Amendments to the Drawings:

DOCKET NO.: RCOH-1039USCON1
Serial No.: 10/730,602
Amdt. dated March 5, 2004
Continuation Application of parent application 09/955,643
Annotated Version

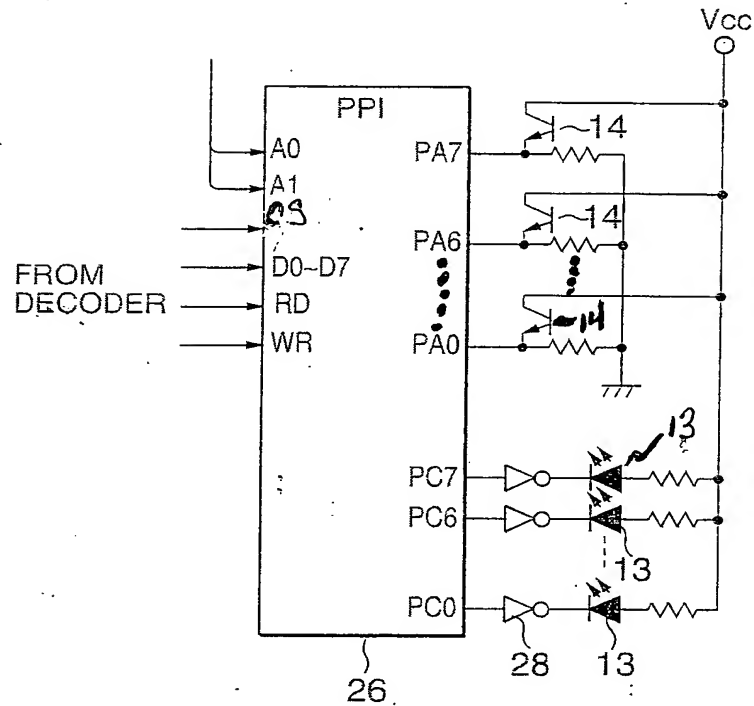
In Fig. 5, element 21, please change "A13" to --A8--. Also in Fig. 5, element 21, please add "WR" under "RD. In Fig. 5, element 21, please "IO/M" to --IO/M--. Also in Fig. 5, element 25, please change "DYR" to --DTR--.

FIG.6

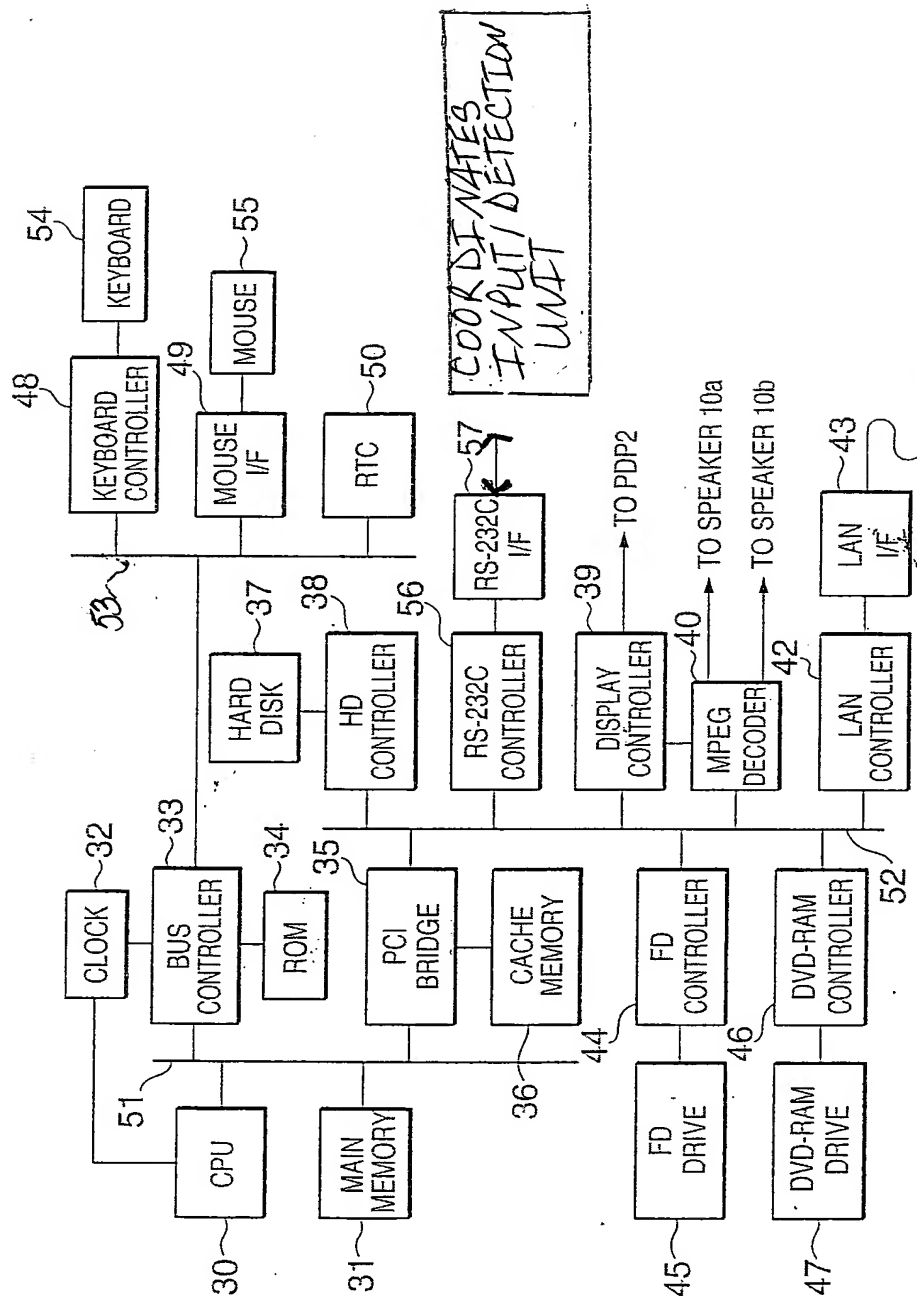
In Fig. 6, element 26, please change "OS" to --CS--. Also in Fig. 6, element 26, please place "...." between PA6 and PA0 as shown in red. In Fig. 6, please add reference numbers "13" and "14" to the drawing. Please also add "...." between the middle and bottom elements as referenced by the reference numbers 1-14.

FIG. 7

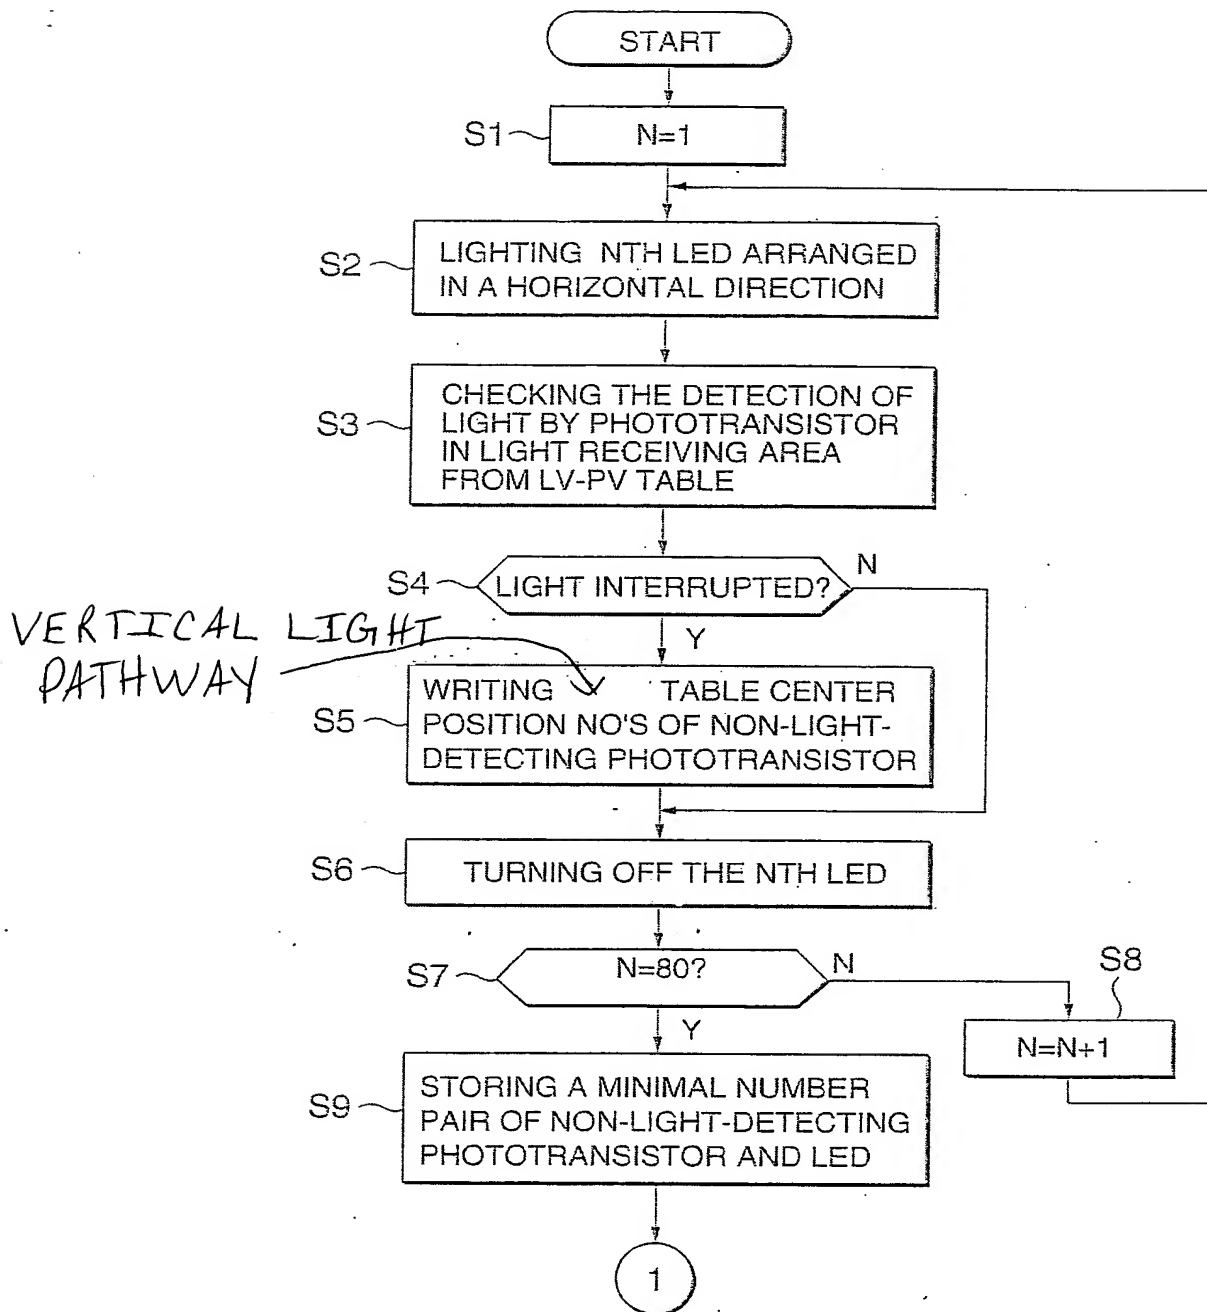
In Fig. 7, please add reference number "53" to the drawing. Also in Fig. 7, outside of element 57, please change the line to a double headed arrow and add a box for a new element at one end of the double headed arrow containing "COORDINATES INPUT/ DETECTION UNIT."

FIG.14

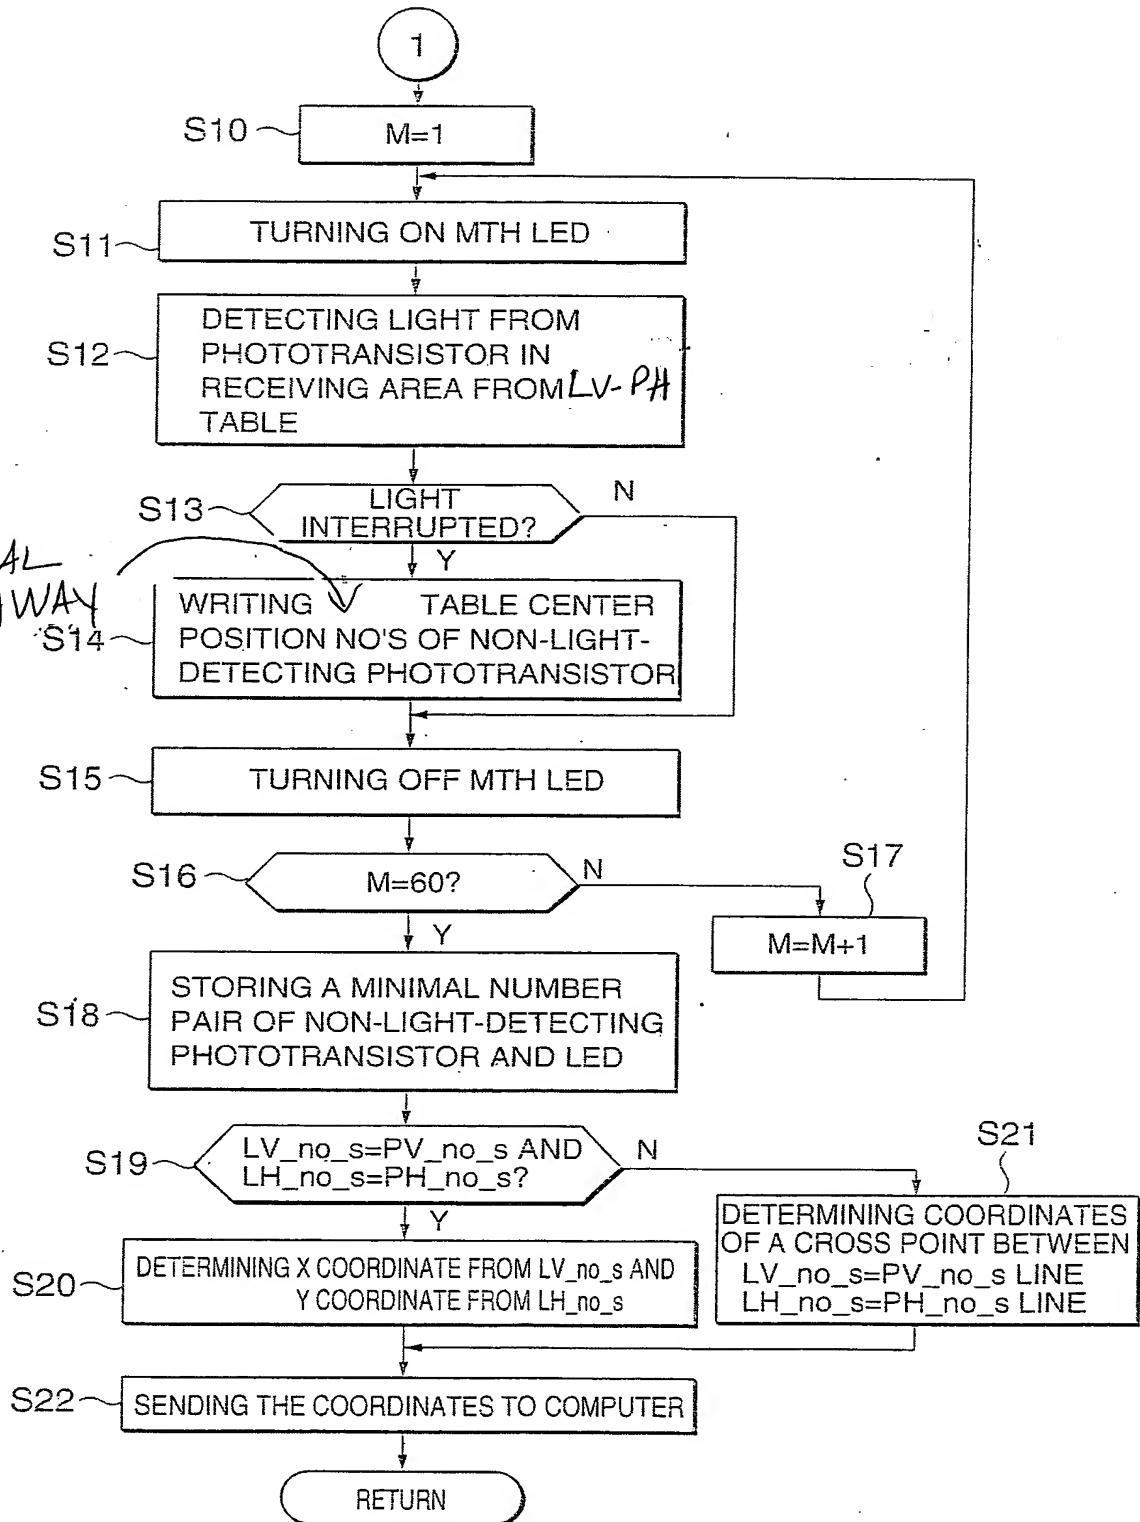
In Fig. 14, step S5, please delete "LV-PV" and insert --VERTICAL LIGHT PATHWAYS--.

FIG.15

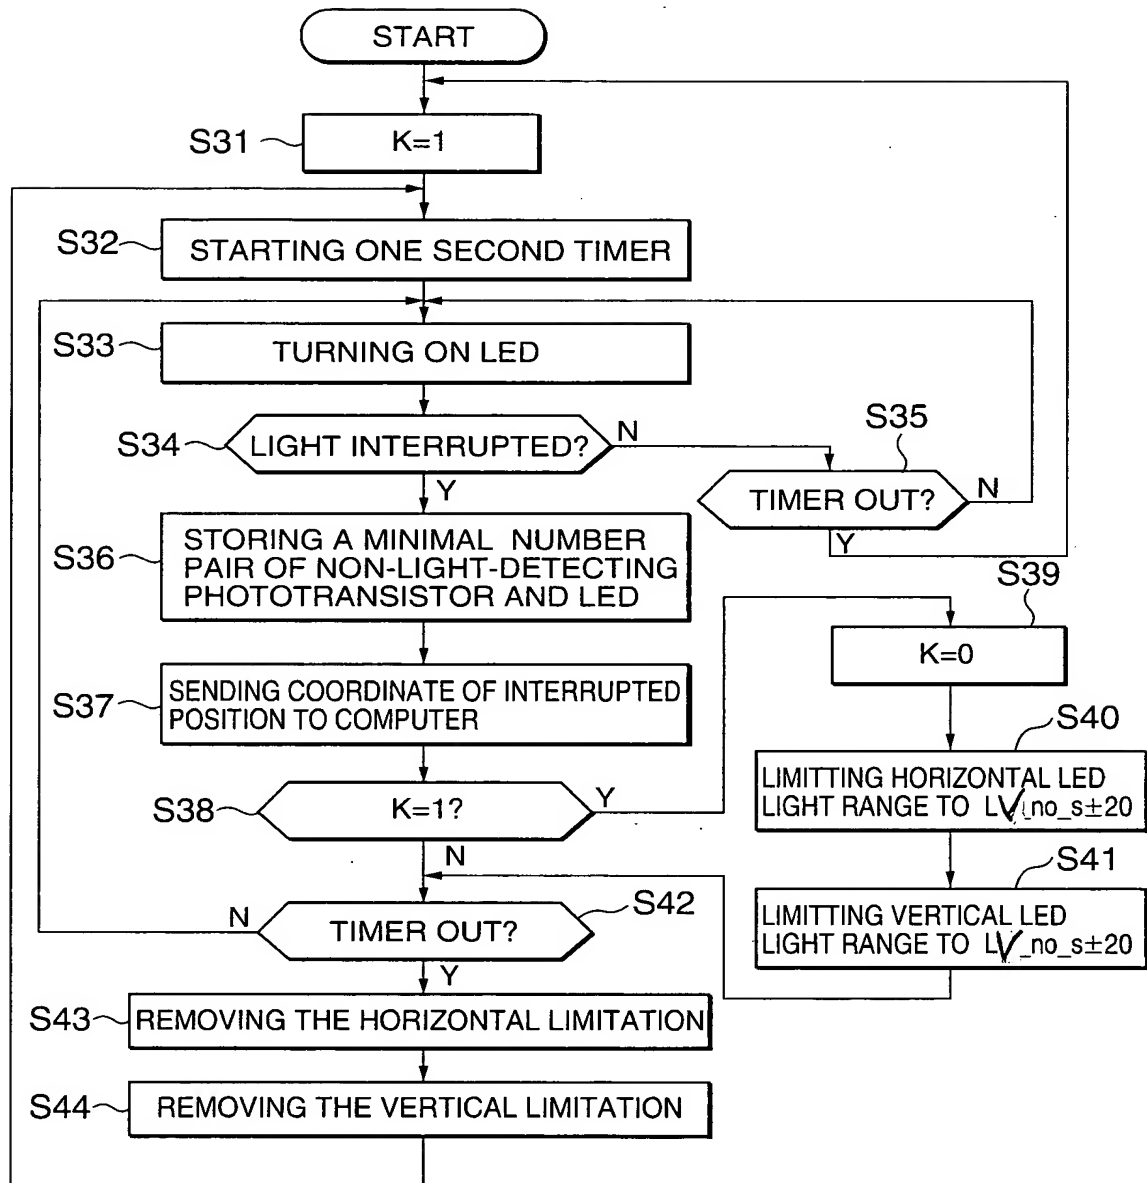
In Fig. 15, step S12, please change "LV-PV" to --LV-PH. Also in Fig. 15, step S14, please delete "LV-PV" and insert --HORIZONTAL LIGHT PATHWAYS--.

FIG.16

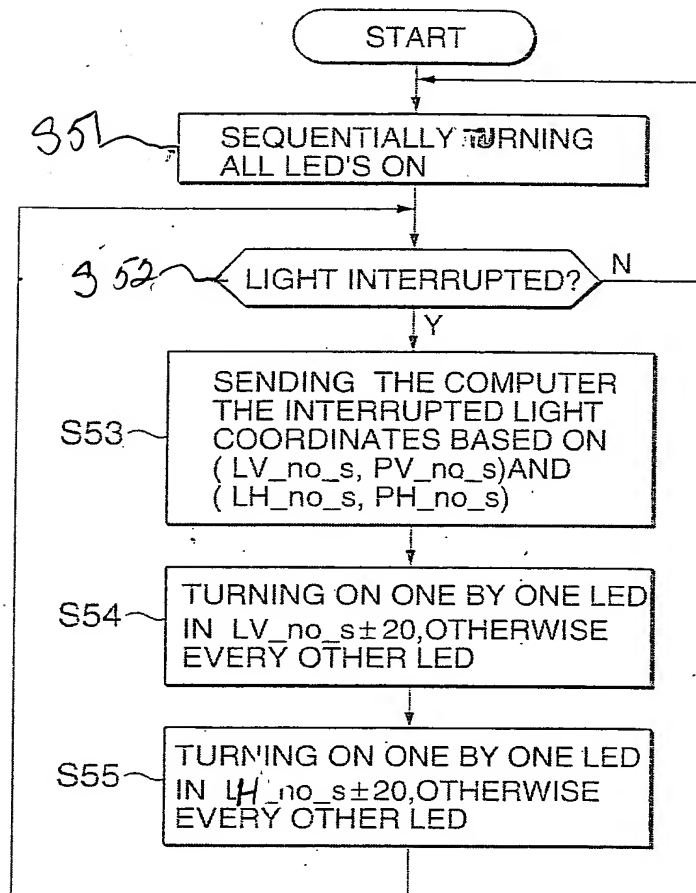
In Fig. 16, steps S40 and S41, please change "LH" to --LV--.

FIG.17

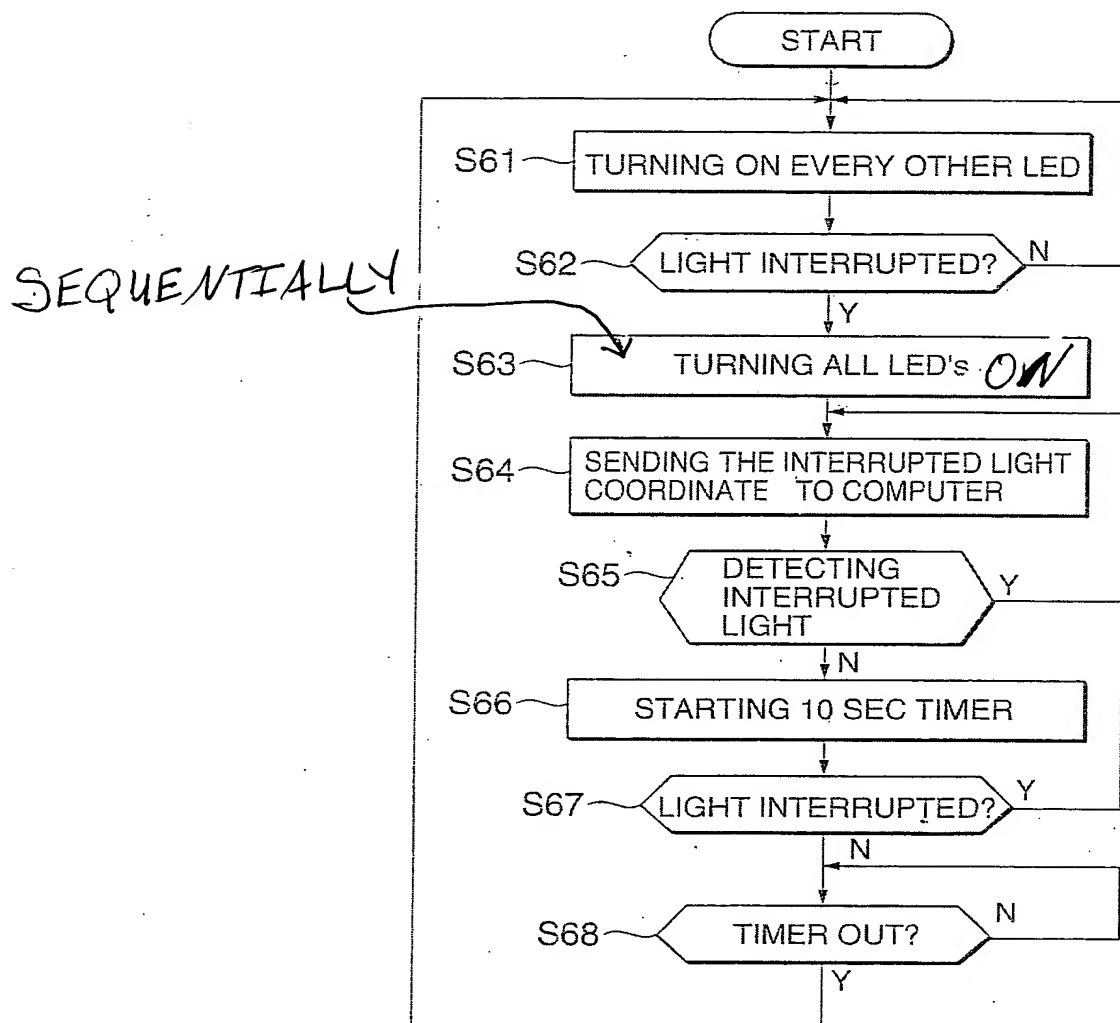
In Fig. 17, please add step --S51-- and --S52-- and please change "LF" to --LH-- in step S55. Please add space between "Sequentially" and "Turning" in step S51.

FIG.18

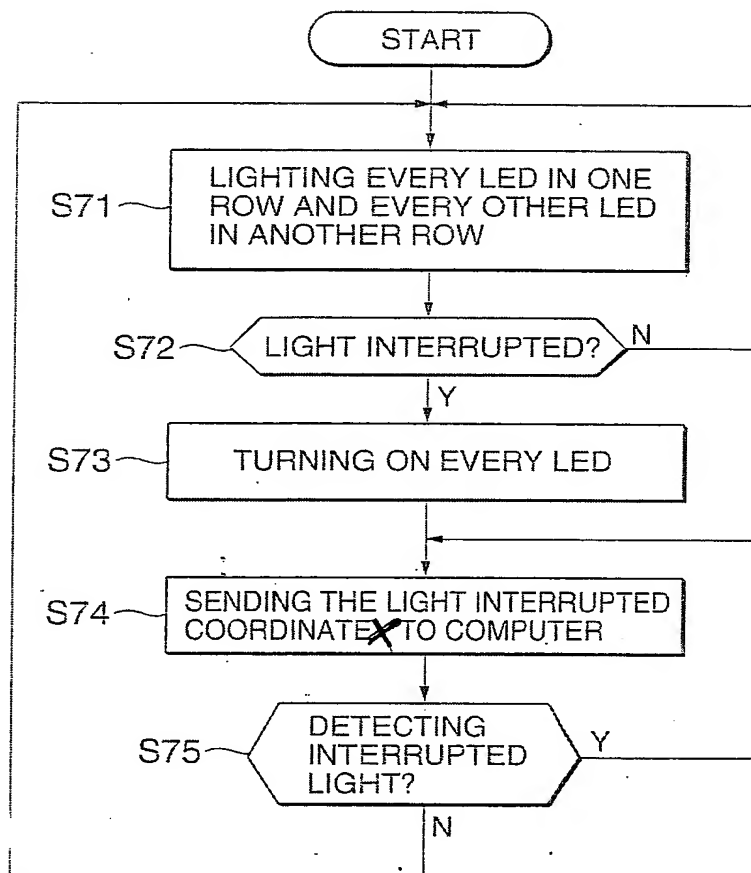
In Fig. 18, step S63, please add --SEQUENTIALLY-- before "TURNING" and --ON--after "LED's." In the step S64 please change "COORDINATES" to --COORDINATE--.
